ANNE CLEMENTS & ASSOCIATES PTY. LIMITED
(ABN 41 077 242 365, ACN 077-160-939)
Environmental and Botanical Consultants
PO Box 1623, North Sydney 2059
Phone: (02) 9955 9733, Facsimile: (02) 9957 4343
Email: mail@acabotanic.com

Responses to flora issues raised by the Department of Planning, Parramatta City Council, the Department of Environment and Climate Change

Department of Planning, Parramatta City Council and the Department of Environment and Climate Change have requested further flora related information on the following issues for MP 08_0258 – Early Works Package at 61 Mobbs Lane, Epping. The requested additional information is provided below.

Tree Number 927 *Eucalyptus pilularis* located between a shed and a fence with little soil near the tree.

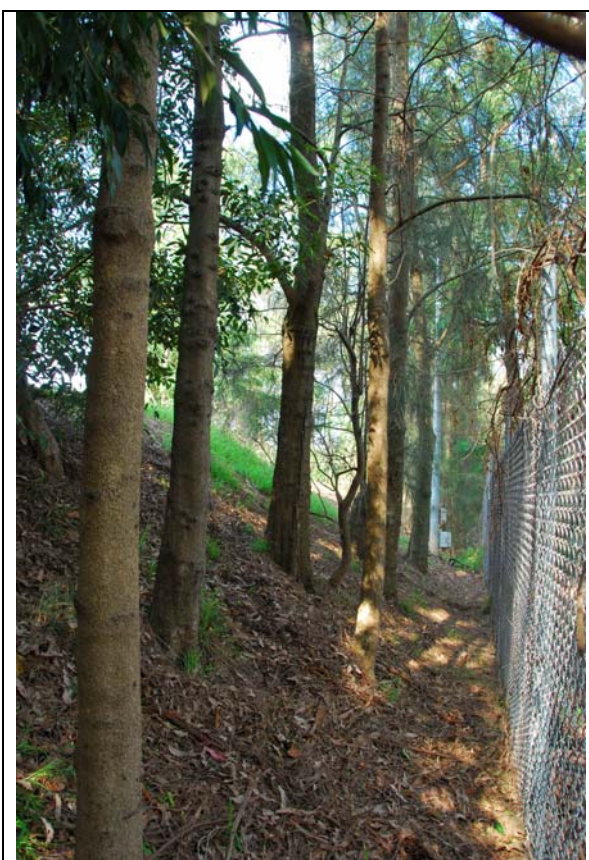
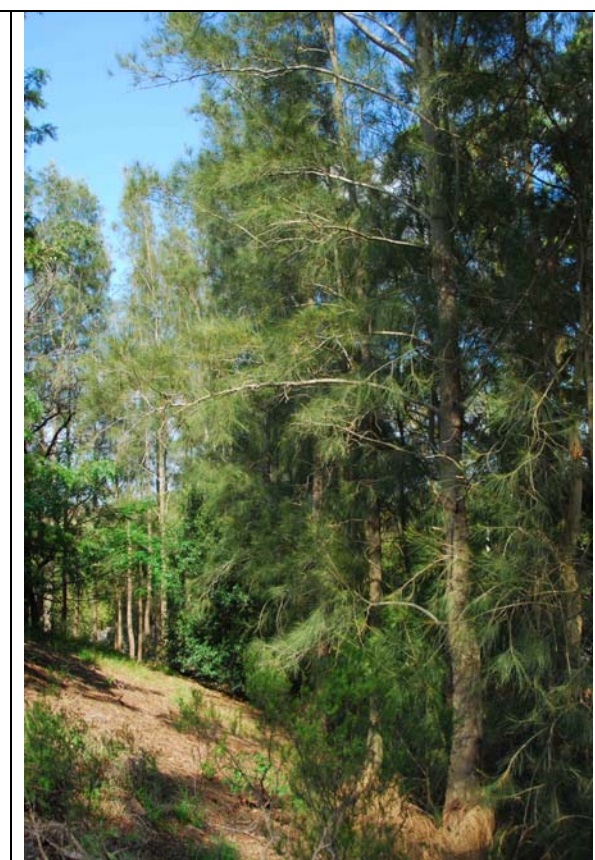
- *Two very large trees of Eucalyptus saligna and E. pilularis, which are characteristic species of Blue Gum High Forest (BGHF), were recorded to the north – east of the helipad, within the pre – 1750 BGHF area. The report does not provide any data on whether there is any native understorey here, or examine whether the vegetation in*

this area meets the definition of BGHF. Therefore, the proposal may result in an impact on BGHF that has not adequately been assessed.

Most of the trees on the Site have been planted in the last 50 years and the understorey of the Site predominantly consists of mown lawns. Of the 1019 trees surveyed by Clements et al. (2005), only 11 were considered likely to be remnant:

- o nine *Angophora floribunda* located along the northern fenceline adjoining Grimes Lane (tree numbers 658, 663 to 668, 700 and 701); and
- o two very large trees recorded to the north-east of the helipad: tree number 927, *Eucalyptus pilularis* (Blackbutt) and 928, *Eucalyptus saligna* (Sydney Blue Gum).

The areas surrounding and near the trees to the north-east of the helipad (tree number 927, *Eucalyptus pilularis* (Blackbutt) and tree number 928, *Eucalyptus saligna* (Sydney Blue Gum)) (see Figure 2 of Clements et al. 2009) was re-inspected and photographed by Anne Clements and Tony Rodd on 23 February 2009. There was little or no area of natural soil surrounding the two trees. There was no understorey under these trees. After the removal of the sheds there may be regrowth of flora from the soil seed bank.
